Access for People with Disabilities

Design Compliance Report

Proposed new storeroom at South Curl Curl SLSC

Report Number & Revision:	MSA2499_DDA_DA_Rev02
Prepared For:	Northern Beaches Council
Date of Issue:	01.12.2022

Figure 2.1.1 – Floor plan extract with new works highlighted in green.

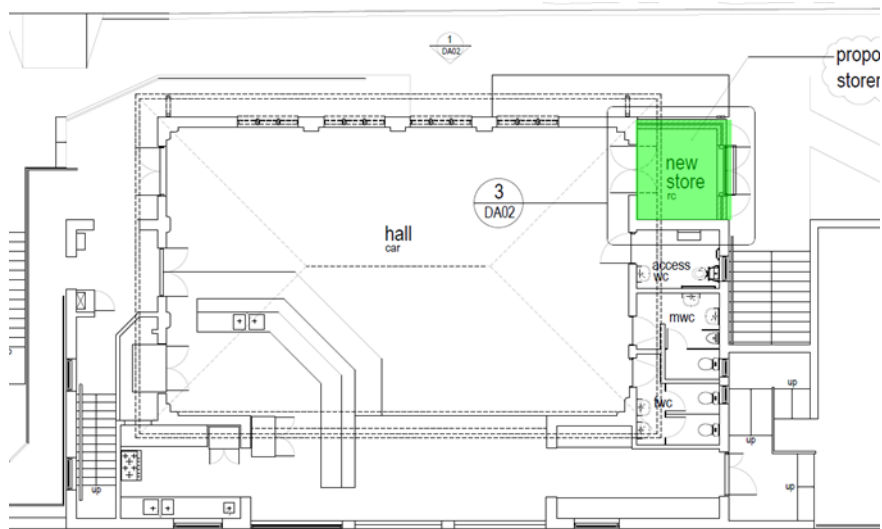
The proposed works comprise the extension of the existing building to create a storeroom (which will be accessed internally and externally) – refer to floor plan extract in Figure 5.1.1 below.
